## **PAPA JOE'S PLACE SUBDIVISION**

Engineering Comments: FINAL PLAT COMMENTS (should be addressed prior to submitting the FINAL PLAT for review and/or signature by the City Engineer):

The preliminary plat illustrates the proposed 2-lot, 0.4± acre subdivision which is located on the West side of Pinemont Drive, 101'± South of Hofner Street, within Council District 6. The applicant states that the subdivision is served by city water and sanitary sewer systems. The purpose of this application is to create two (2) legal lots of record from three (3) existing lots of record.

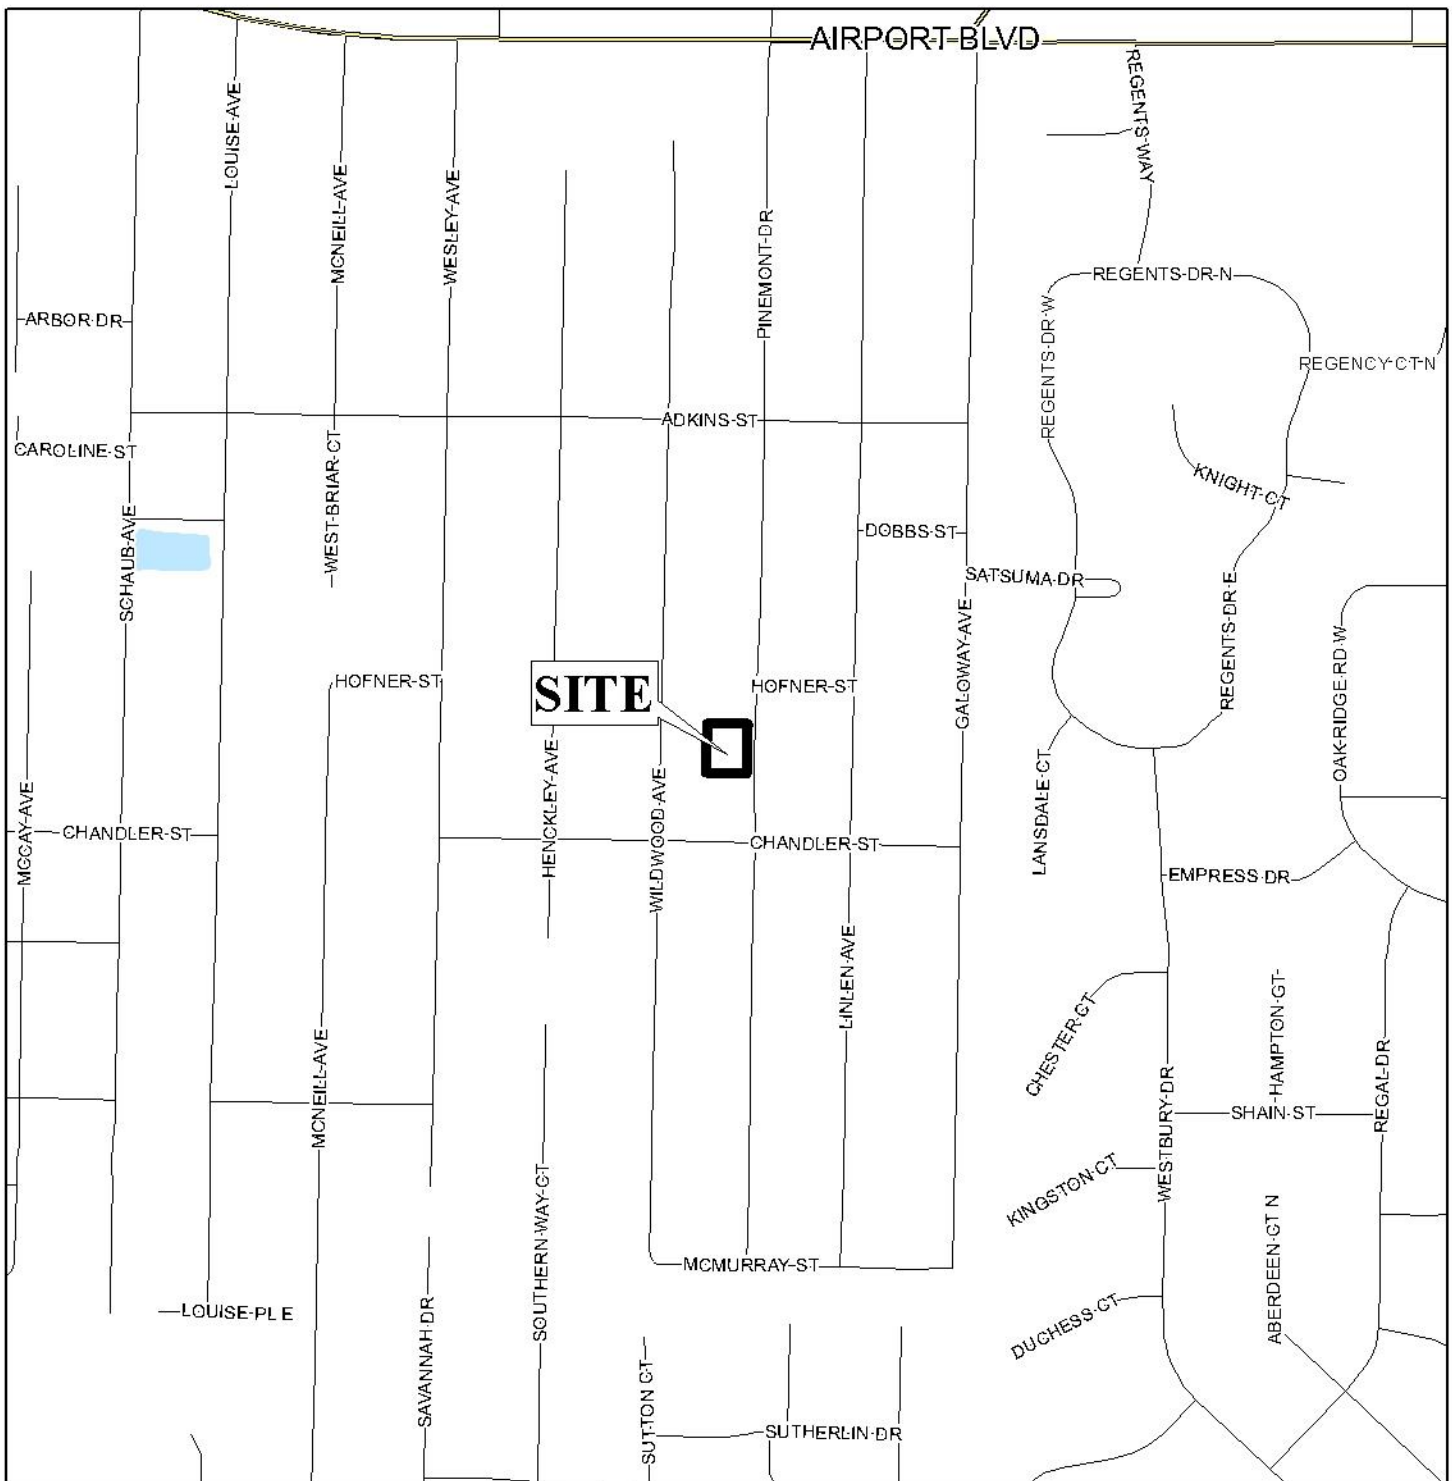
As proposed, both Lots A and B have frontage along Pinemont Drive, a minor street without curb and gutter. As such, the preliminary plat illustrates a compliant 60' wide right-of-way; therefore, no dedication would be required.

The proposed Lot A exceeds the 7,200 square foot minimum required by Section V.D.2. of the Subdivision Regulations, whereas the proposed Lot B is 6,250 square feet, making it sub-standard in size. In addition to being sub-standard in overall square feet, the proposed Lot 2 is 50-feet wide, and Section V.D.2. of the Subdivision Regulations states that lots should be a minimum of 60-feet wide. However, given that the site currently consists of three (3) existing sub-standard size lots, all of which were originally approved as 50-feet wide, and the proposed Lot B will have more square footage than any individual existing lot, a waiver of Section V.D.2. of the Subdivision Regulations may be appropriate. If approved, both lot sizes should be retained on the Final Plat in both square feet and acres, adjusted for dedication.

The 25' minimum required front setback is depicted along both frontages, and should be retained, on the Final Plat if approved.

No easements are indicated on the preliminary plat. If any easements are recorded on the site they should be indicated and labeled on the Final Plat, and a note should be placed on the Final Plat stating that no structure may be placed or constructed within any easement without permission of the easement holder.

It should be noted that the proposed Lot A is depicted as having a utility room/carport structure approximately four and a half (4 ½) feet from the proposed Northern property line. A minimum side yard setback of eight-feet is required for all structures taller than three-feet. Therefore, if approved, either the utility room/carport structure will need to be re-located to a compliant setback distance, removed from the site, or a variance obtained to remain in its current location. It should also be noted that the structure is within the required eight-foot setback along the West property line, however as that property line is not being proposed to change, the structure may be considered non-conforming.

With a waiver of Section V.D.2. of the Subdivision Regulations, the plat meets the minimum requirements of the Subdivision Regulations and is recommended for Tentative Approval subject to the following conditions:

- 1) Retention of the lot size labels in both square feet and acres on the Final Plat, or the furnishing of a table on the Final Plat providing the same information;

- 2) Retention of the 25' minimum building setback line;
- 3) Either relocation of the utility room/carport structure to a compliant setback distance, remove it from the site (with appropriate permits), or obtain a variance to remain in its current location prior to signing the Final Plat;
